Groundwater Transfer Review Summary Form

Transfer/PA # T- 13769 (RA)

Application: T-13769 re-review

Applicant Name: The Buck Family Trust c/o Cam Buck

Theis Drawdown Analysis – RU #1, Maximum Pumping, Interference with MARI 2362

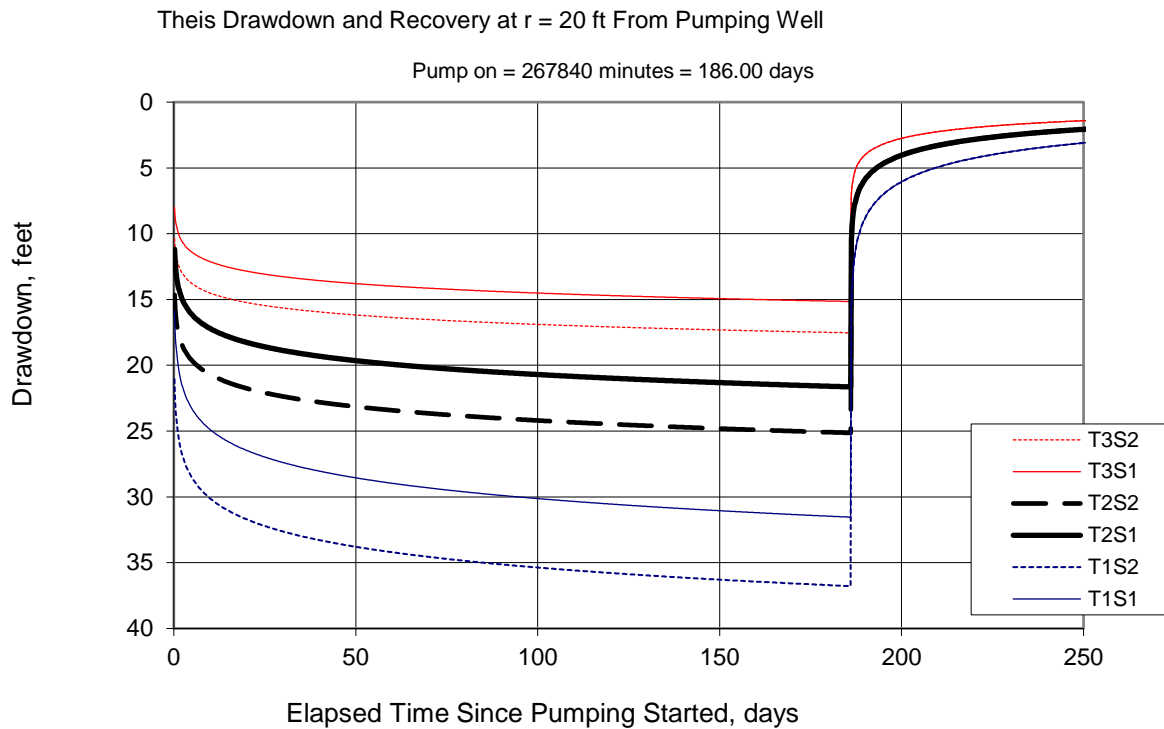
☐ Yes ☒ No If yes, explain: The Theis (1935) solution for drawdown in a confined aquifer was used to estimate the potential for injury to nearby senior groundwater users (see attached Theis Drawdown Analysis). Results of the analyses indicate the proposed pumping of the To-POA is unlikely to cause injury to neighboring senior rights.

Unit	Source
Depth to water	15 ft bls	Log MARI 2362
Total depth	245 ft bls	Log MARI 2362
Water Column	230 ft	
Min Avail Drawdown	175 ft	Theis analysis, $r=1$ ft, $Q=2.0$ cfs
Pump buffer	10 ft	
Min Water Column	185 ft	
Interference Threshold	45 ft
